Thor Motor Coach Technical Service Bulletin

TSB #	TSB 22-13		
Description/Title:	2022 Omni & Magnitude with Firefly software(v7.25 or later)		
Affected Product Line(s):	Certain model year 2022 Omni & Magnitude		
Service Campaign # :	RC000283	Released Date:	11/8/2022
Codes:	Inspect with Repair: TMCTS80279W	Document Date:	11/7/2022
Time Allowed:	Inspect with Repair: .1	Document Revision:

FIG 1

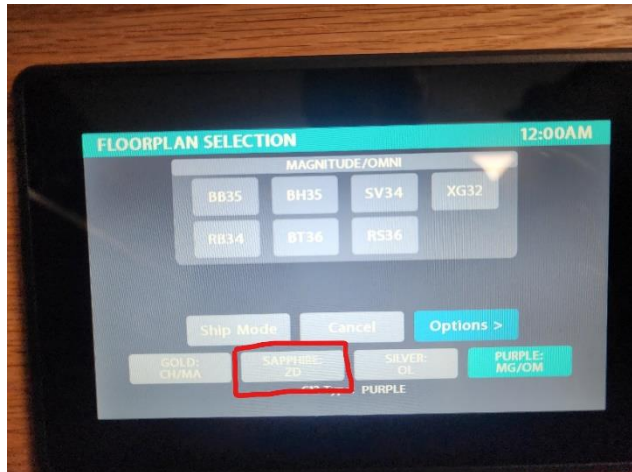
1. Press and hold the floorplan button.
2. Go to floorplan settings/options page
3. Select "Sapphire" in the bottom row of buttons (Fig 1, circled in red)
4. On this page, you will see "Inverter Brand" selection which lists both a "MAGNUM" and "XANTREX" selection (Fig 2, circled in red).
 - a. If either button is blue (indicating selected), that is the cause of I/C controls appearing on the screen.
5. Both of those buttons must be deselected, just like the Red circled area in Fig 2 shows below.
